UNITED STATES PATENT AND TRADEMARK OFFICE

APPLICATION NO.	FILING DATE	FIRST NAMED INVENTOR	ATTORNEY DOCKET NO.	CONFIRMATION NO.
10/675,260	09/30/2003	Mark Adam Bachman	Bachman 2-9-165-45-32/246	4045
29391	7590	12/21/2004	EXAMINER NGUYEN, THINH T	
BEUSSE BROWNLEE WOLTER MORA & MAIRE, P. A. 390 NORTH ORANGE AVENUE SUITE 2500 ORLANDO, FL 32801			ART UNIT 2818	
PAPER NUMBER

Office Action Summary

DETAILED OFFICE ACTION

FIG. 4(c)

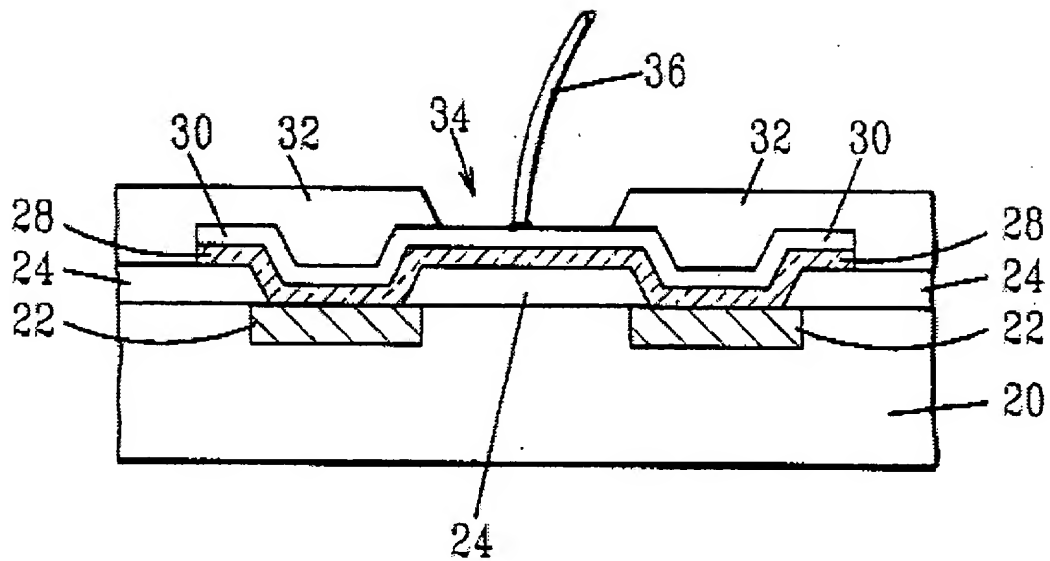
Costrini et al. (the abstract, fig 4© , fig 4(a)) disclose an integrated circuit comprising: a contact pad (fig 4(a) layer 30, column 5 lines 17-30) formed of a metal; a reinforcing layer(layer 28) underlying said contact pad, said reinforcing layer (column 4 lines 64-67, column 5 line 1-7) being formed of a metal different than the metal of the contact pad; at least one metal layer (layer 22) under said reinforcing layer; and at least one dielectric layer(layer 24) disposed under said reinforcing layer.

Costrini et al. (the abstract, fig 4© , fig 4(a),column 5 line 5) disclose an integrated circuit comprising a reinforcing layer that comprises tungsten or tantalum. Those metals are refractory.

To expedite prosecution, The Examiner assume that the applicant claim some sort of pattern. If that is the case, then claim 3 is anticipated by both Costrini et al (in fig 4©) and Pozder et al. (fig. 2)

Costrini et al. (the abstract, fig 4© , fig 4(a),column 5 lines 23-30) disclose an integrated circuit with contact pad wherein the metal the metal of the contact pad is selected from the group comprising aluminum, copper and alloys of aluminum and copper.

Costrini et al. (the abstract, fig 4© , fig 4(a),layer 28, column 5 lines 1-7) disclose an integrated circuit with contact pad wherein the metal of the reinforcing layer is selected from the group comprising titanium, titanium nitride, tungsten, tungsten nitride, nickel, and alloys or combinations thereof.

FIG. 2

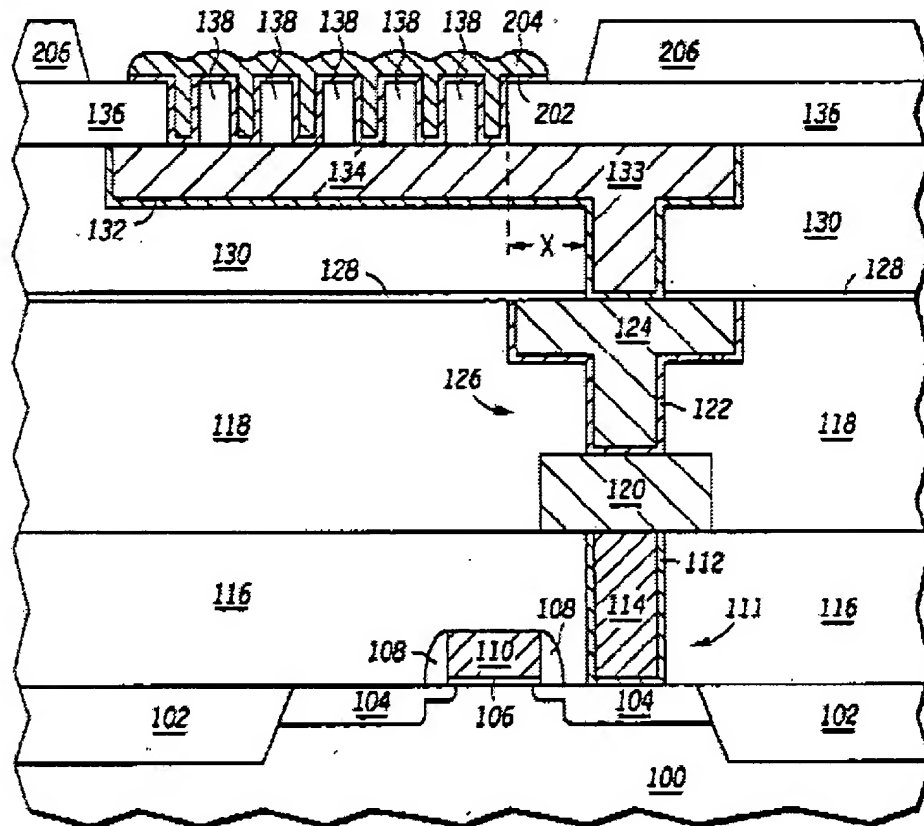
Similarly, Pozder et al. (the abstract, fig 2 layer 204,layer 202,layer 134, layer 136)

disclose the same invention

Similarly, Pozder et al. (the abstract, fig 2 layer 204,layer 202,layer 134, layer 136,column 5 lines 24-26) disclose the same invention

Similarly, Pozder et al. (the abstract, fig 2 layer 204,layer 202,layer 134, layer 136,column 5 lines 29-30) disclose the same invention.

Similarly, Pozder et al. (the abstract, fig 2, layer 202 ,column 5 lines 23-25) disclose the same invention.
